Agenda Language: Approve Modification No. 9 to Contract No. 4400001633, Kiewit Building Group, for Executive Office Building (EOB) HVAC Upgrades Project.

SUBJECT: Executive Office Building HVAC Upgrades
Kiewit Building Group, Change Order Number 09
Contract No. 4400001633

CHANGE ORDER No. 9:

Executive Office Building HVAC Upgrades
IFB No. B1306-028-JT
Contract No. 4400001633

REFRIG. & CO DETECTION SYST.
 PROJ. T9.33 , TRAVIS CO. EOB

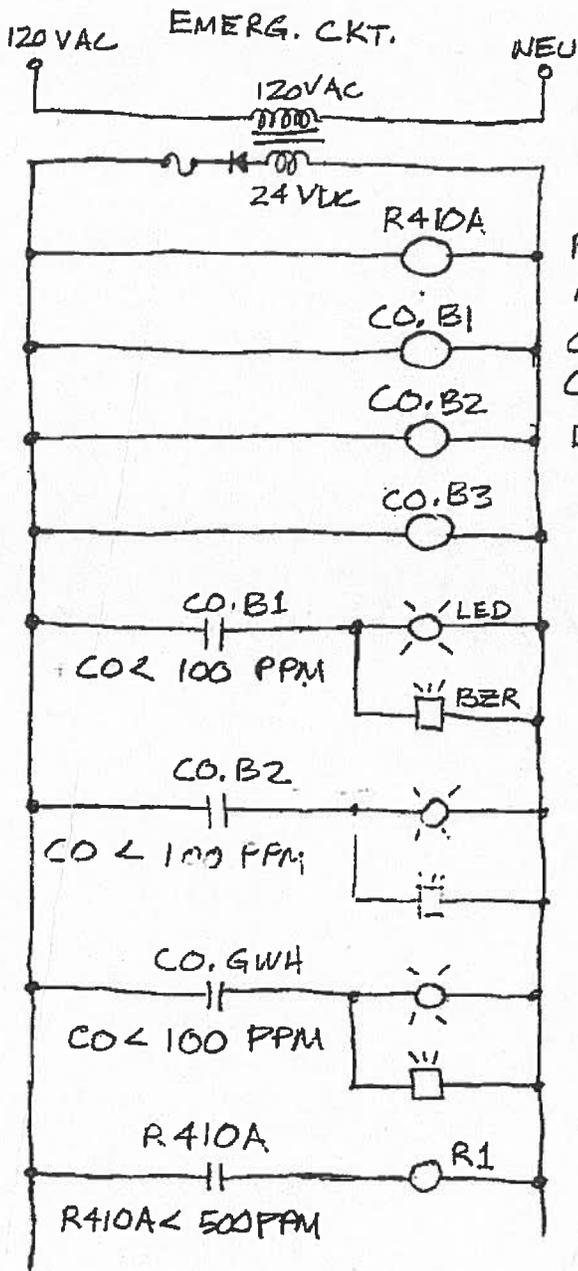
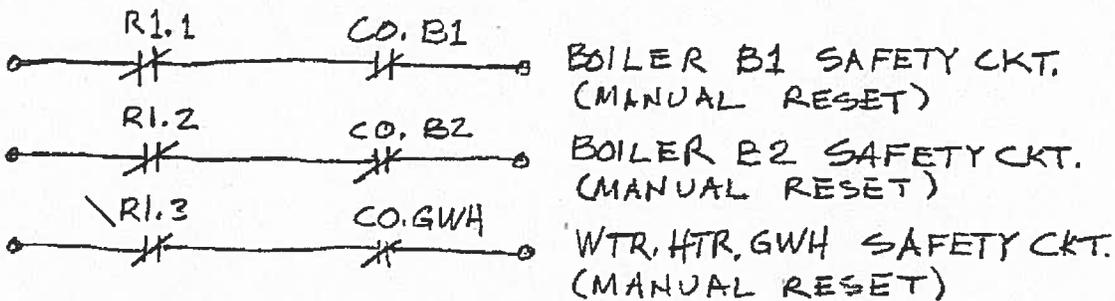
Please provide controls sequence of operations for the refrigerant/CO2 detection system in the penthouse. This system is required to be ready by May 5th to obtain our temporary certificate of occupancy. Please expedite response.

Please see attached wiring diagram with parts list, plus cut sheets from submittal and from internet for the parts. Please verify that the boilers and water heater have contacts for a normally-shortened external safety circuit, and that they require manual reset. If there are any deficiencies there, please get back to me with that information so I can prepare minor modifications to the wiring diagram.

NO. OF SHEETS	10
NO. OF SHEETS USED	10
DATE	01/15/04 REV 1
PROJECT NO.	008-17-100-01
CONTRACT NO.	
DATE	
DESIGNED BY	AV
CHECKED BY	AL
SHEET TITLE	LOBBY FLOOR PLANS
SHEET NUMBER	A1.1

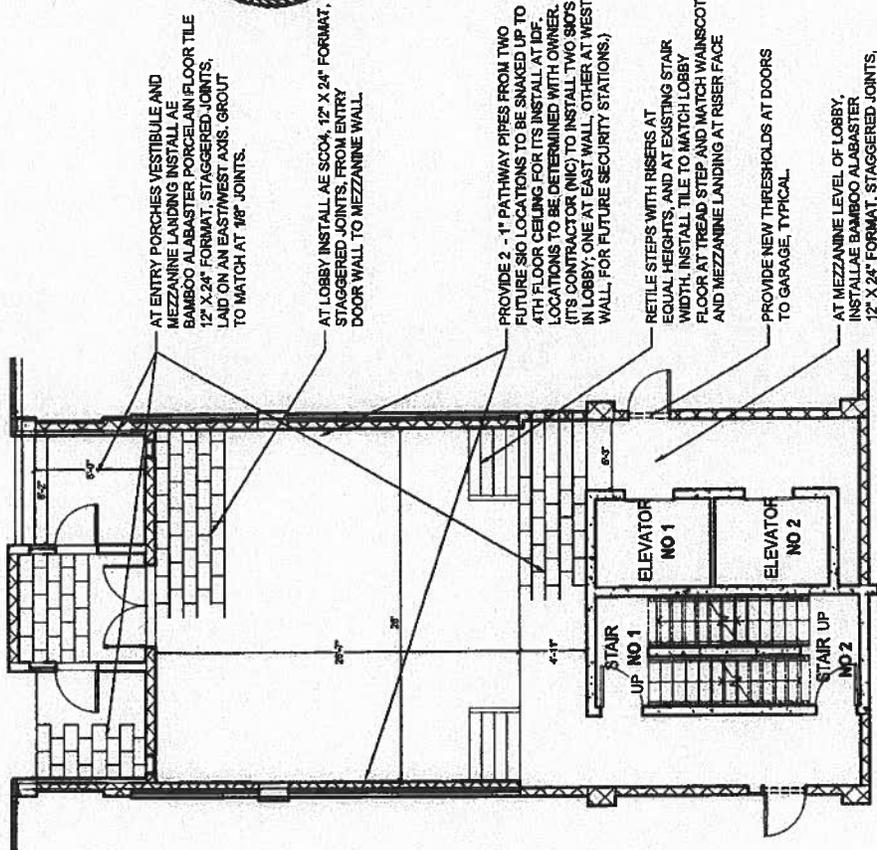
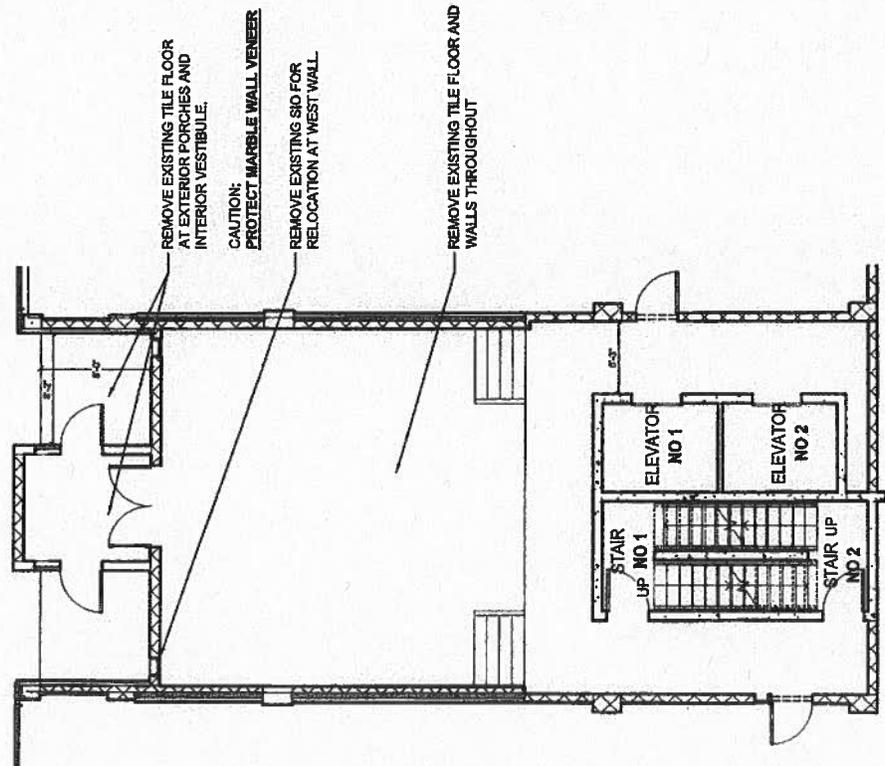
AT ENTRY PORCHES VESTIBULE AND MEZZANINE LANDING INSTALL AE BAMBOO ALABASTER PORCELAIN FLOOR TILE 12" X 24" FORMAT, STAGGERED JOINTS, LAID ON AN EASTWEST AXIS. GROUT TO MATCH AT 1/8" JOINTS.

AT LOBBY INSTALL AE SC04, 12" X 24" FORMAT, STAGGERED JOINTS, FROM ENTRY DOOR WALL TO MEZZANINE WALL.

PROVIDE 2 - 1" PATHWAY PIPES FROM TWO FUTURE SIG LOCATIONS TO BE SNAKED UP TO 4TH FLOOR CEILING FOR ITS INSTALL AT DF. LOCATIONS TO BE DETERMINED WITH OWNER. (IT'S CONTRACTOR (NIC) TO INSTALL TWO SIG'S IN LOBBY; ONE AT EAST WALL, OTHER AT WEST WALL, FOR FUTURE SECURITY STATIONS.)

RETILE STEPS WITH RISERS AT EQUAL HEIGHTS, AND AT EXISTING STAIR WIDTH. INSTALL TILE TO MATCH LOBBY FLOOR AT TREAD STEP AND MATCH WAINSCOT AND MEZZANINE LANDING AT RISER FACE

PROVIDE NEW THRESHOLDS AT DOORS TO GARAGE, TYPICAL.

REMOVE EXISTING TILE FLOOR AT EXTERIOR PORCHES AND INTERIOR VESTIBULE.

REMOVE EXISTING SIG FOR RELOCATION AT WEST WALL.

REMOVE EXISTING TILE FLOOR AND WALLS THROUGHOUT

SHEET NUMBER
A1.2

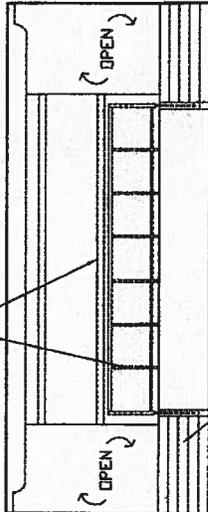
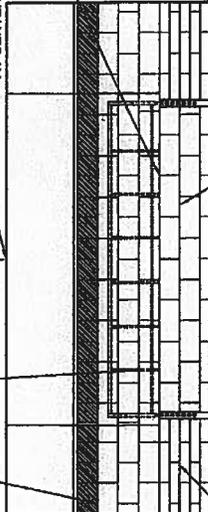
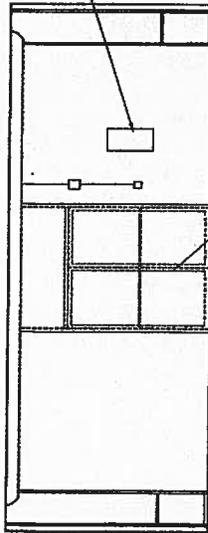
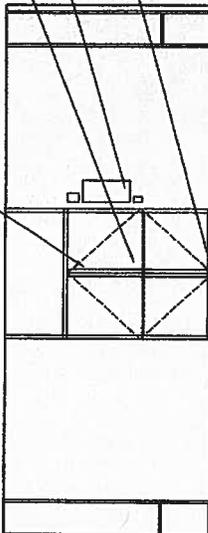
REMOVE EXISTING GUARDRAIL/HANDRAIL
REMOVE EXISTING CHAIR RAIL/HAT RAILS ON SOUTH WALL

REMOVE EXISTING TILE STEPS ARE TO BE REBUILT. TYPICAL. KEEP EXISTING WIDTH.

12"x12" DECORATIVE GLASS TILE BAND WITH 2 INCH BULLNOSE CAP OVER 12"x24" WALL-TILE WAINSCOT ALL AROUND.

EXISTING RAILING TO BE REPAINTED. ADD FLOOR TOPPING AT BASE OF MEZZANINE LANDING OUT 8 FEET TO REDUCE LANDING DROP-OFF TO 24" TO FEATHER FLOOR TILE ELEVATION TO 6 INCHES HIGH AT BOTTOM STAIR RISER.

START VERTICAL JOINTS FOR CEILING, MEZZANINE WALL TILE AND FLOOR TILE AT CENTERLINE OF ROOM

INSTALL EDGE TRIM TO MATCH FLOOR TILE

TOPPING AT BOTTOM STEP TO BE OF EQUAL RISER HEIGHT. STEPS TO RECEIVE AE PORCELAIN TILE SC04, ALUMINUM NOSINGS.

REMOVE EXISTING FIRE EXTINGUISHER. PROVIDE NEW RECESSED CABINET IN LOCATION TO BE DETERMINED BY OWNER.

REMOVE ALL THREE EXISTING ENTRY DOUBLE DOORS, TRANSOMS, SIDELIGHTS AND ALL ASSOCIATED HARDWARE

INSTALL NEW, REGULAR ALUMINUM STOREFRONT ENTRY, NARROW STYLE.

PROVIDE NEW THRESHOLDS FOR NEW GLASS ENTRY SYSTEMS

SHEET NUMBER
A1.3

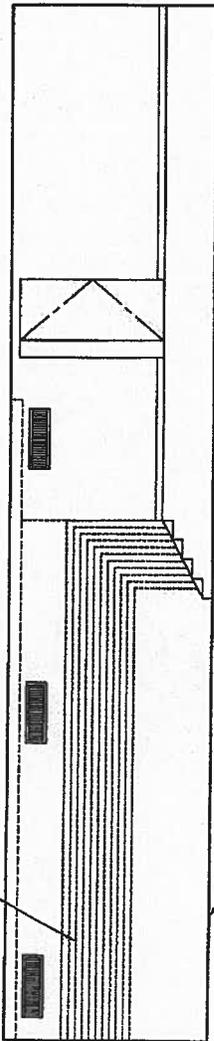
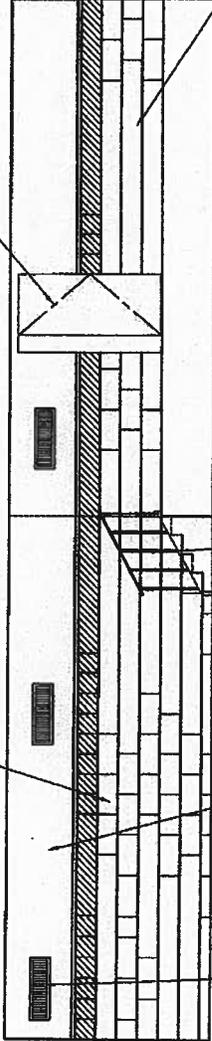
REMOVE EXISTING MIRRORRED WALL COMPONENTS AND ALL ASSOCIATED BACKING AND HARDWARE, TYP. SIM. O.H. NEW GYPSUM WALLS, PAINT AND FINISHES. EXISTING WALLBOARD REMOVED UNDER OTHER ABATEMENT CONTRACT.

DEMO FLOOR TILES TO STRUCTURE.

INSTALL 12"x24" PORCELAIN TILE, AMERICAN CLEAN BAMBOO ALABASTER 3 FEET AFF AT MEZZANINE WITH 12"x12" GLASS TILE, DAL TILE BLANCO WHITE 4" AFF CARRIED BY 2" BULLNOSE CAP, CHARCOAL GRAY COLOR CHOICES TO BE VERIFIED BY ARCHITECT.

PAINT WALLS

PROVIDE TOPPING GROUT SLOPED OUT FROM MEZZANINE LANDING WALL 8 FEET FROM APPROX. 1-1/2" NICH TO 0" TO ACHIEVE 8" AT BOTTOM RISER STEP TO HAVE RISERS AT EQUAL HEIGHT, AND ACCORDING TO TEXAS ACCESSIBILITY STANDARDS. PAINT EXISTING HANDRAIL PER ARCHITECT'S COLOR SELECTION.

SHEET NUMBER
A1.4

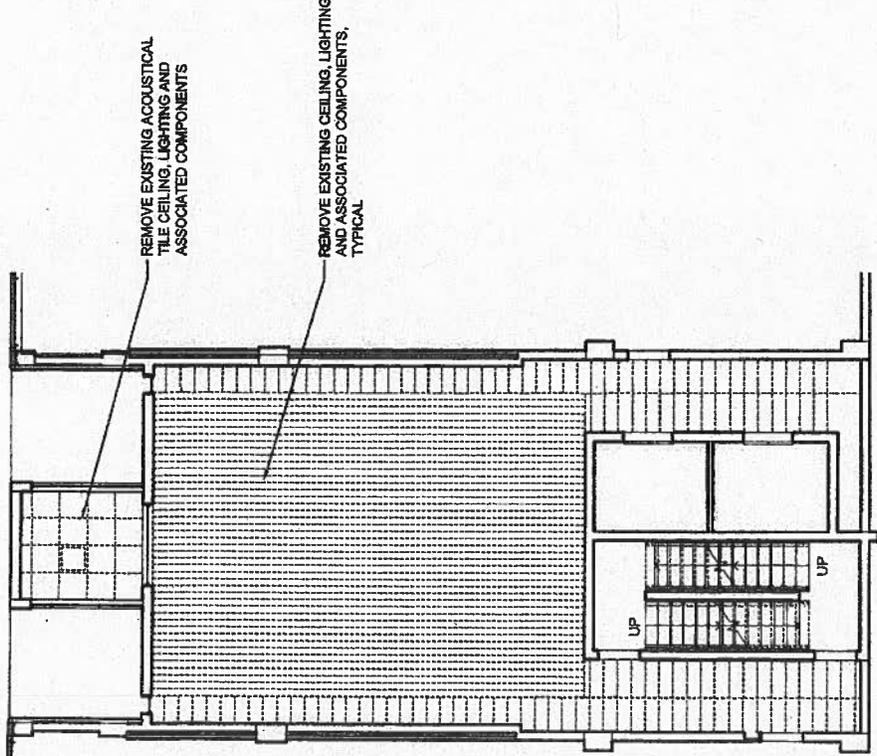
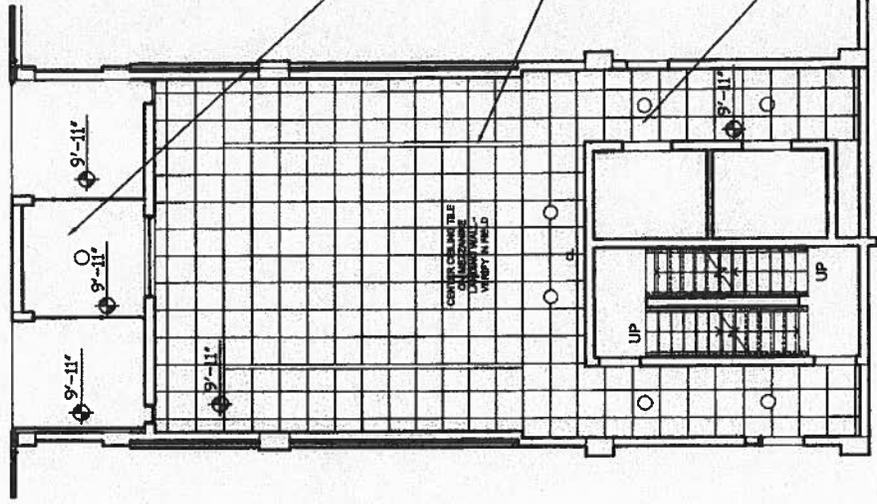
GENERAL NOTES
1. REINSTALL EXISTING LIGHTS, TYPICAL
2. AFTER CEILING DEMOLITION, REVIEW EXISTING CEILING HEIGHTS IN LOBBY TO DECIDE FINAL ELEVATIONS.
